WINDMILL RIDGE ESTATES NO. 3A					
JAMES SMITH SURVEY ABST. NO. 200					
City of Rockwall, Rockwall County, Texas					
John C. Gibson Co Inc. Consulting Engineers					
9510 Military Parkway Dallas, Texas 75227					
DESIGN	DRAWN	SCALE	NOTES	FILE	NO
JCG Co Inc	RJH	1" = 100'	R.D.	Windmill Ridge 3A	2

Re: First Review
Windmill Ridge, Phase 3-A
ROK 85884

Applicant: Centennial Homes Case No. 85-68-FP
Property Description Windmill Ridge III A
Case Subject Matter Final Plat

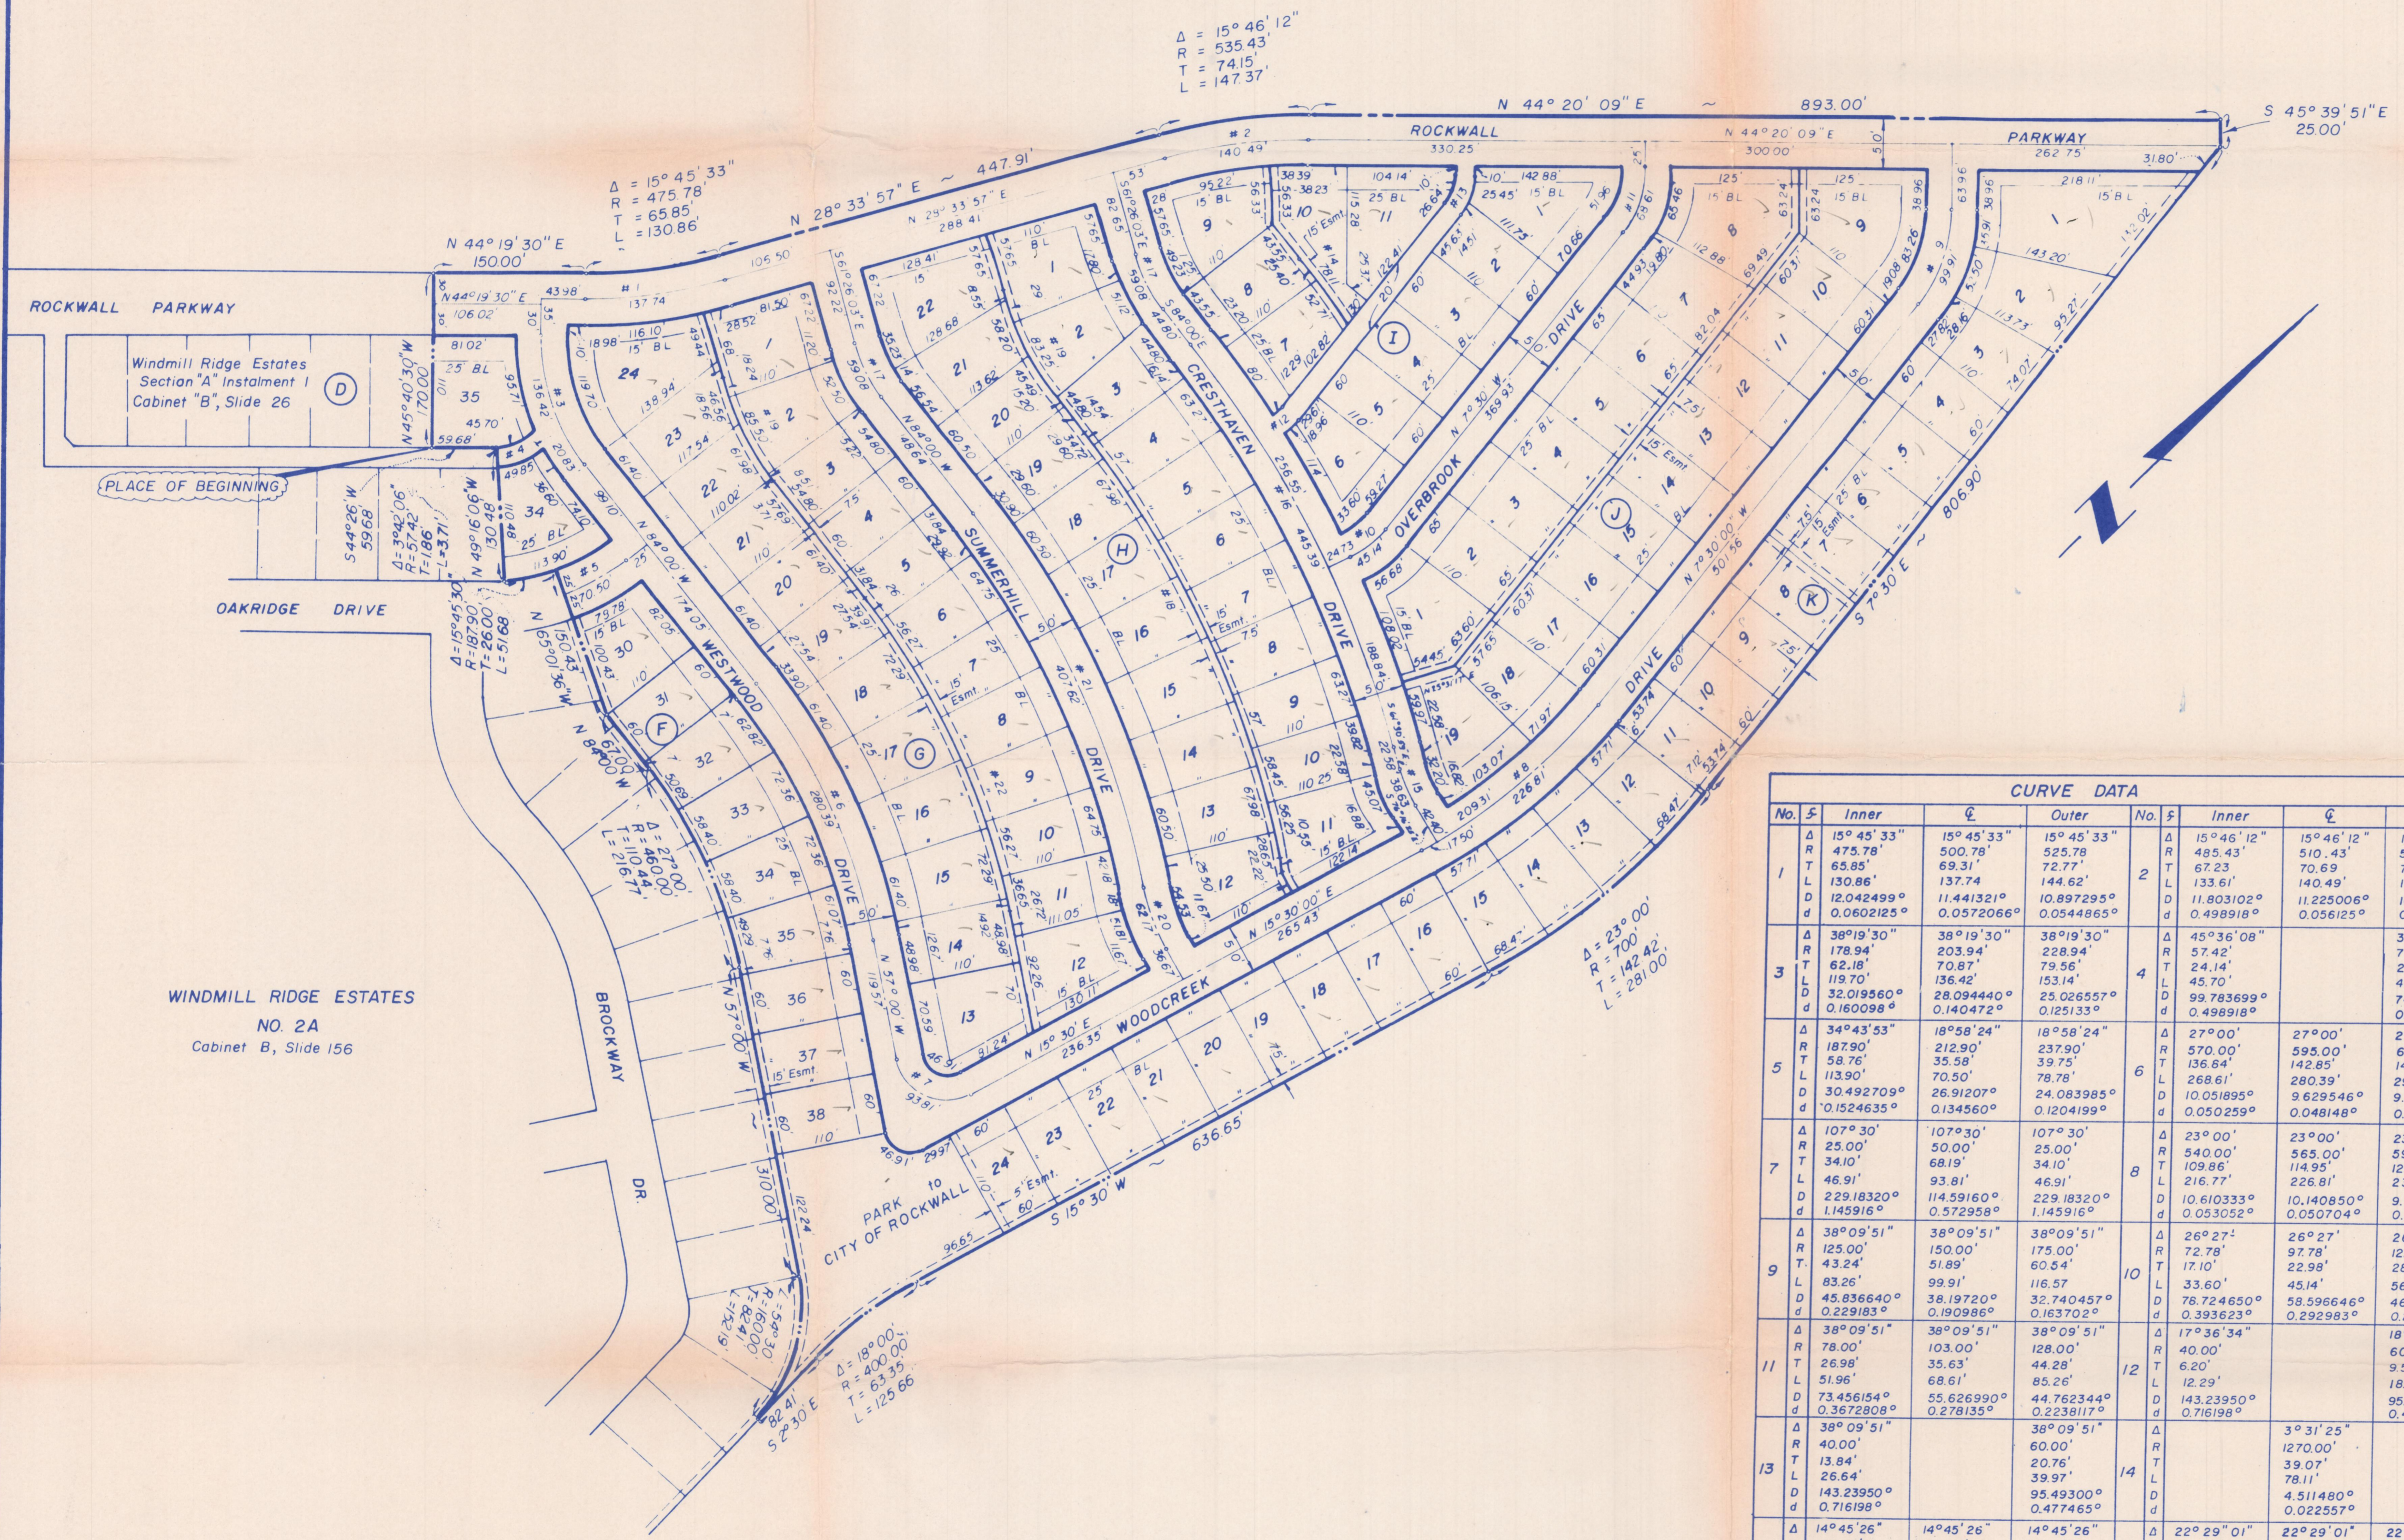
The plat as submitted does meet our technical requirements. We asked that the open area be labeled "park". The engineering has been submitted to our engineers for review.

1. Change label from "open area" to "park"
2. Submit plat to all utility companies immediately to avoid delays in assigning easements

The plat as submitted does meet our technical requirements. We asked that the open area be labeled "park". The engineering has been approved.
